FORM APPROVED
OMB NO. 1004-0135
Expires: July 31, 2010**SUNDRY NOTICES AND REPORTS ON WELLS**
Do not use this form for proposals to drill or to re-enter an abandoned well. Use form 3160-3 (APD) for such proposals.

1. Type of Well <input checked="" type="checkbox"/> Oil Well <input type="checkbox"/> Gas Well <input type="checkbox"/> Other		5. Lease Serial No. NMLC066126
2. Name of Operator CIMAREX ENERGY COMPANY Contact: TERRI STATHEM E-Mail: tstathem@cimarex.com		6. If Indian, Allottee or Tribe Name
3a. Address 202 S. CHEYENNE AVE, STE 1000 TULSA, OK 74103-3001	3b. Phone No. (include area code) Ph: 918-295-1763	7. If Unit or CA/Agreement, Name and/or No.
4. Location of Well (Footage, Sec., T., R., M., or Survey Description) Sec 26 T20S R34E NWNW 660FNL 440FWL		8. Well Name and No. HANSON 26 FEDERAL 1H
		9. API Well No. 30-025-40327
		10. Field and Pool, or Exploratory LEA; BONE SPRING SOUTH
		11. County or Parish, and State LEA COUNTY, NM

Cimarex Energy Inc. respectfully requests approval to change the rig layout as indicated on the attached diagram.

Exhibit D-1
 Production Facilities Layout Diagram
Hanson 26 Federal No. 1
 Cimarex Energy Co. of Colorado
 26-20S-34E
 SHL 660 FNL

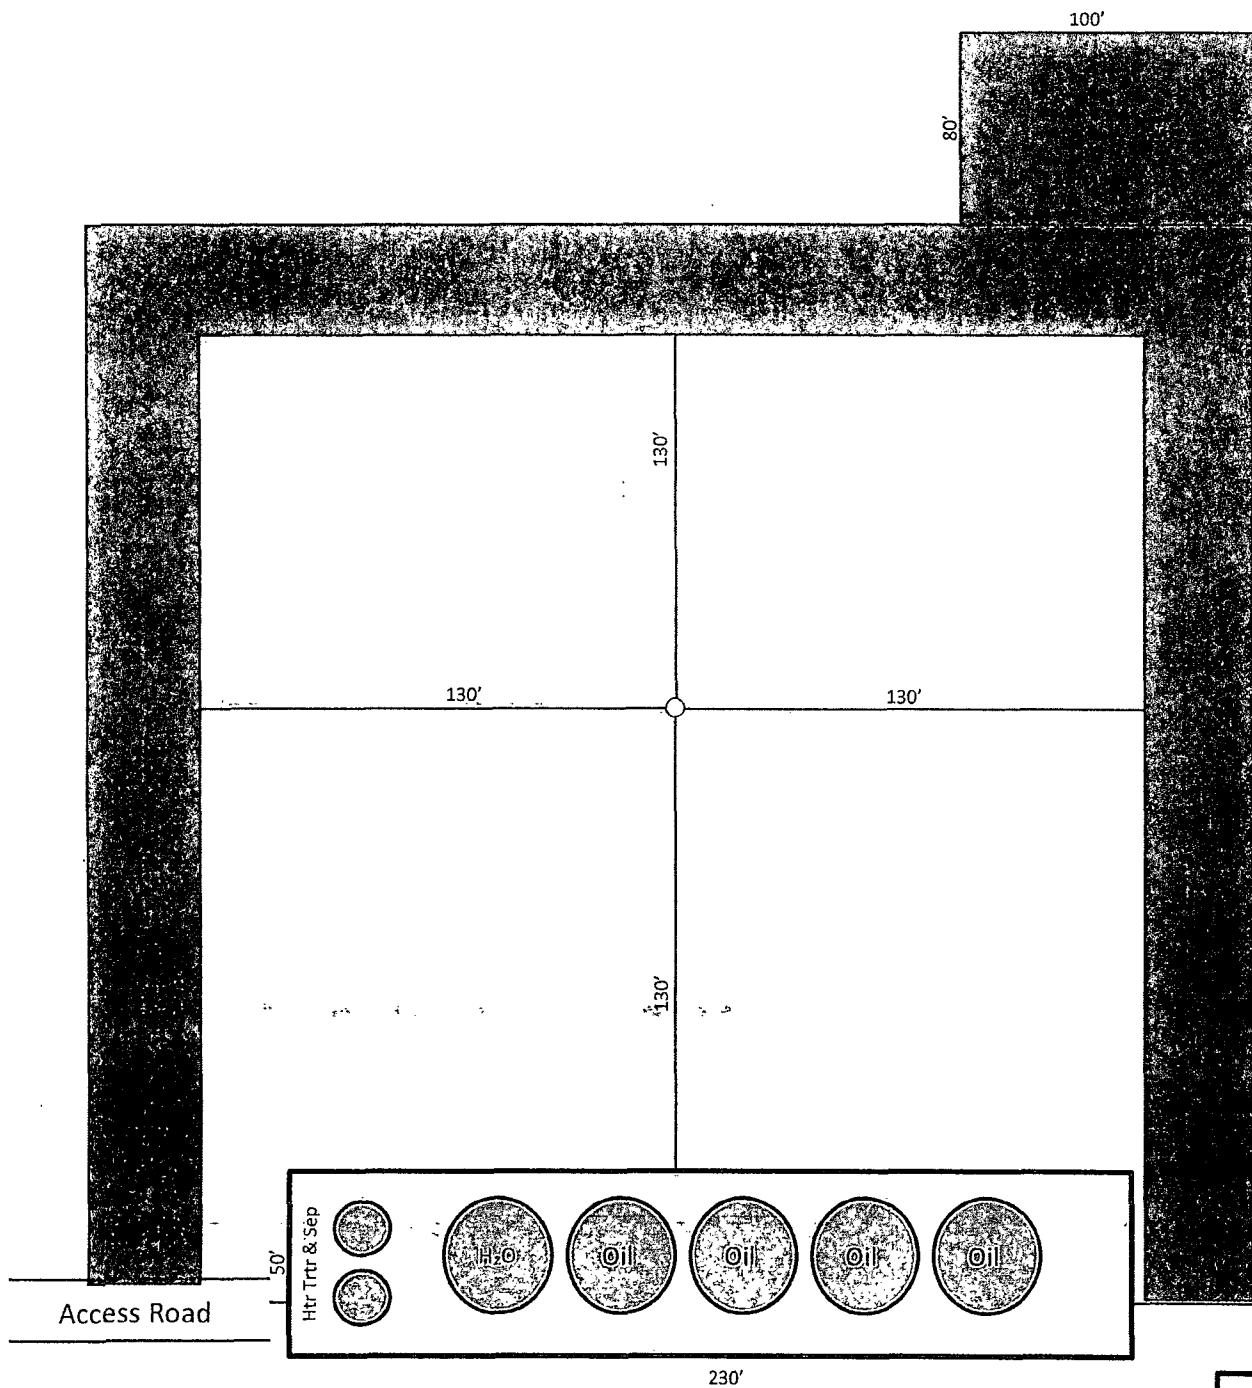
Cimarex is proposing a 380' X 320' drilling pad in order to accomodate the rig requirements.
